REMARKS

The Examiner has rejected claims 9, 12 and 13 as anticipated by US 4,973,102 to Bien. Anticipation exists where each and every material element of a claim is found in a single reference. Applicants do not believe Bien discloses all elements of the amended claims.

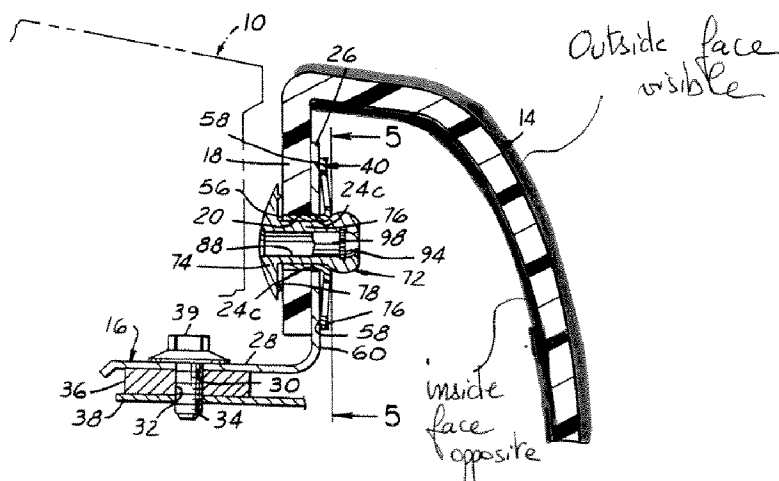
The Examiner argues that Bien discloses support areas 24 (upright flange 26 of the metal angle 16). According to figures 6 and 4 of Bien, support areas 24 conform to the plastic panel 18. The plastic panel 18 does not include a face that is opposite to an outside face visible on an exterior of the vehicle of Bien in that both faces of the plastic panel 18 are hidden and are not visible from the outside of the vehicle. This can be seen on the drawing below, which has been highlighted to show the outside and inside faces of Bien.

Consequently, the support areas 24 of Bien do not substantially conform to an inside face of the fender, opposite to an outside face visible on an exterior of the vehicle. Bien lacks "a support sheet comprising support areas spaced apart from each other and each of which substantially conforms to the inside face".
